## DESCRIPTIVE REPORT (HYDROGRAPHIC)

Type of Survey ..... HYDROGRAPHIC  
Field No. .... DA-5-2-74  
Office No. .... H-9411

State ..... WASHINGTON  
General Locality .. PUGET SOUND  
Locality ..... N.E. PORTION OF COMMENCEMENT BAY

PACIFIC MARINE CENTER  
VERIFIER'S REPORT

**H-9411 (DA-05-02-74)**  
**(Tacoma Harbor)**  
SOUNDINGS IN FEET - SCALE 1:15,000  
**C&GS 6407**  
12th Ed. Jan. 27/73  
(N.D. 18091)

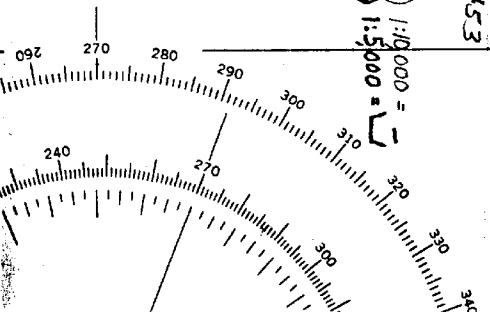
The smooth sheet was compared with Chart 6407 (#18091), 12th Edition, January 27, 1973 (Copy is enclosed.). *now 18453*

Item #1. An inspection of the smooth sheet does not confirm the existence of a reported shoal 400 yards northwest of Dash Point; however, its existence is not conclusively disproven. The Class I manuscript, TP-00729, does not reflect the shoal either. Refer to the Descriptive Report, Paragraph Q, for the hydrographer's recommendation that this area be marked by a floating navigational aid. Additional field work is recommended. *See Q.C.I.*

Item #3. The position of the dolphin in question (which served as signal #506) is confirmed by the Class I manuscript, TP-~~00729~~ and the chart. *Chart as shown on the present survey in lat. 47°18.21', long. 122°26.62'* ✓

Item #6. The single vessel at: Latitude 47°17'23", Longitude 122°25'13" is not plotted on this sheet. It was inferred from the raw data and boatsheet information that this single vessel was temporarily moored at the barge moorage. The position of this vessel falls between position #598 and #599. ✓

Item #7. The marine railway is depicted on the Class I T-sheet, TP-~~00732~~ and is transferred as such onto the smooth sheet.
